Figure 3.22: Baseline Surface Water flows at Stream locations north-east of the site

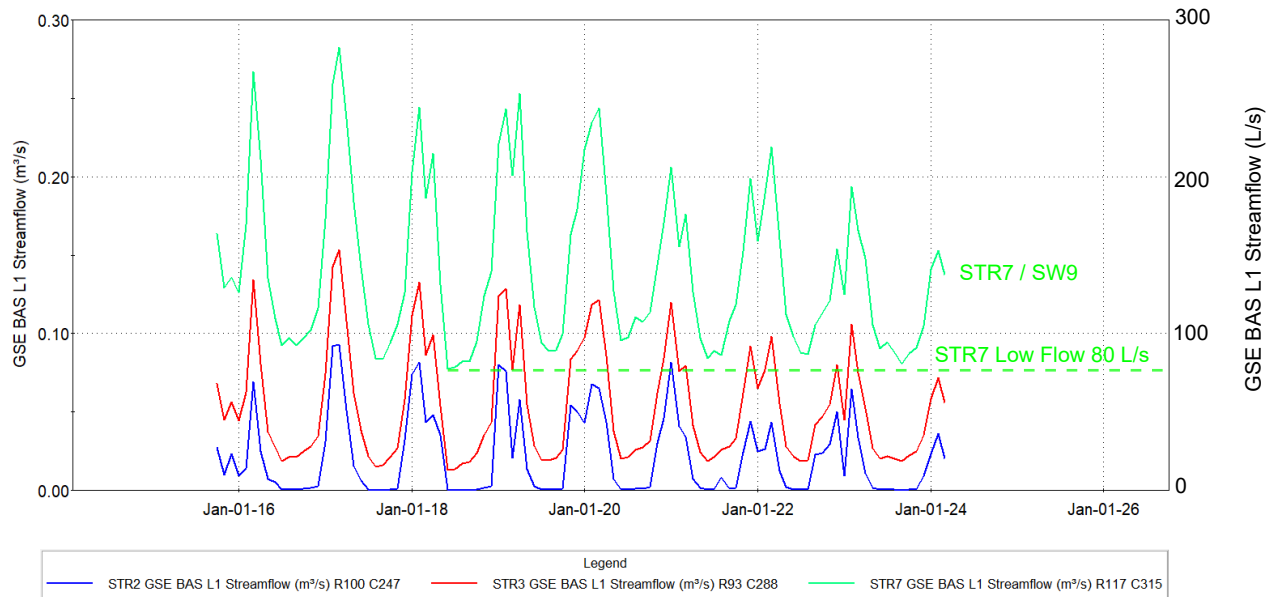
Strada Model Virtual Baseline Flow $80/140 \times 100 = 57\%$ of Mega Quarry Real Flow.
